# SERVICE LETTER

No. 699

Fuel Vent Line Check Valve Installation -- reference attached Lycoming Service Bulletin No. 362A, dated December 14, 1973.

SUBJECT: Fuel Vent Line Check Valve Installation

Figure 1. Fuel Drain Line Check Valve No. LW-12745

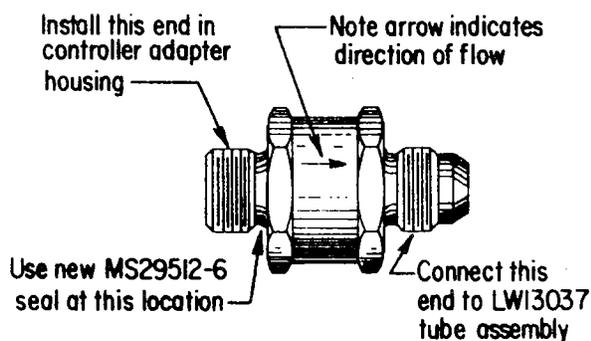
2. Install the LW-12745 check valve with a new MS29512-6 seal in the tapped hole in the adapter assembly from which the union was removed. Be sure the check valve is installed with the arrow (indicating direction of flow) pointing away from adapter assembly. See figure 1. Tighten the valve with 75 to 125 in. lbs. torque.

Figure 2. Top View of Engine Showing Location of Fuel Drain Tube

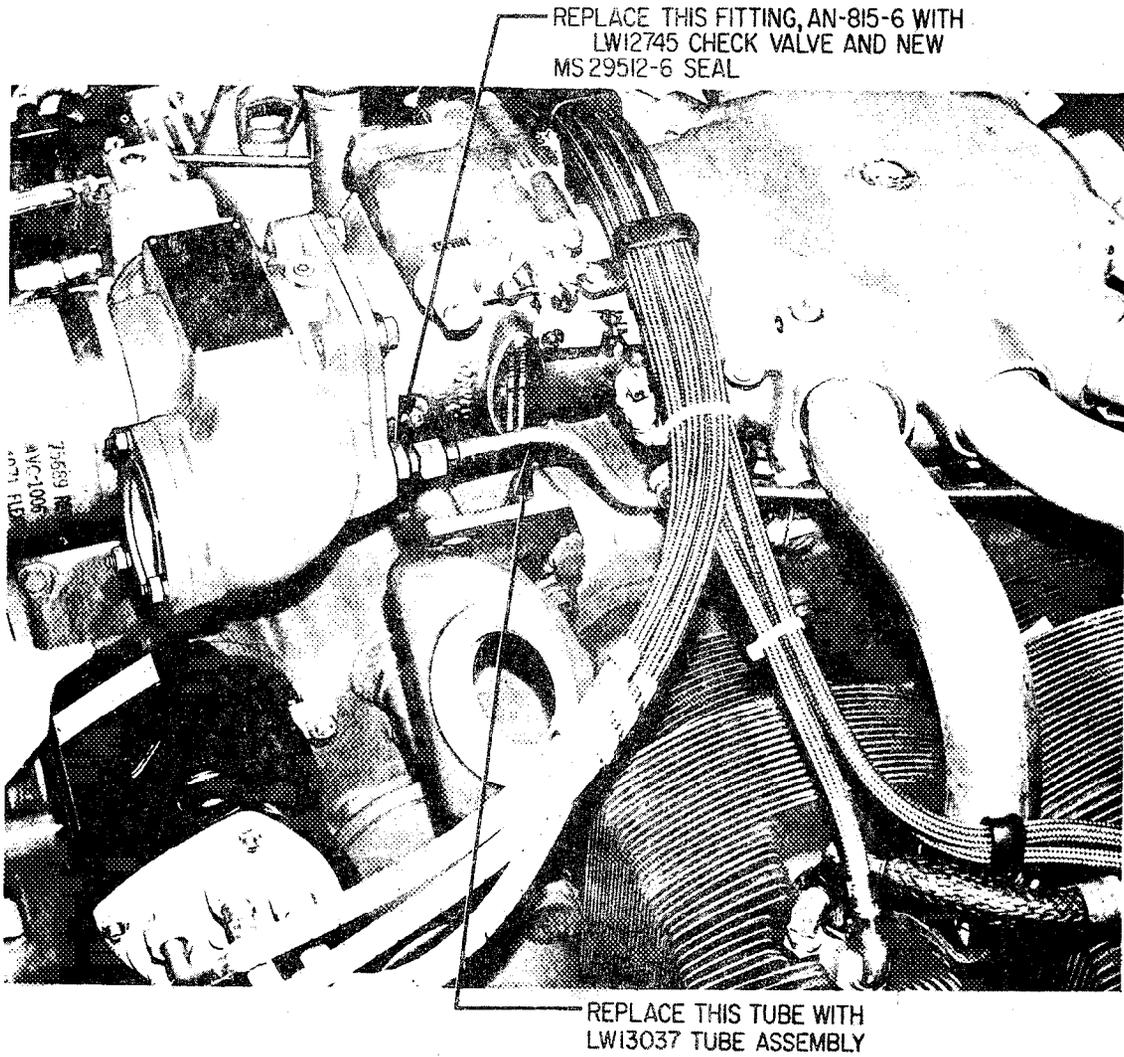
(1) Remove no. 77706 tube that is connected between the induction housing and the controller adapter. See figure 2. Also remove the AN-815-6 union and MS29512-6 seal from the adapter housing.

NOTE: Revision "A" adds TIGO-541 model; changes figure 2.
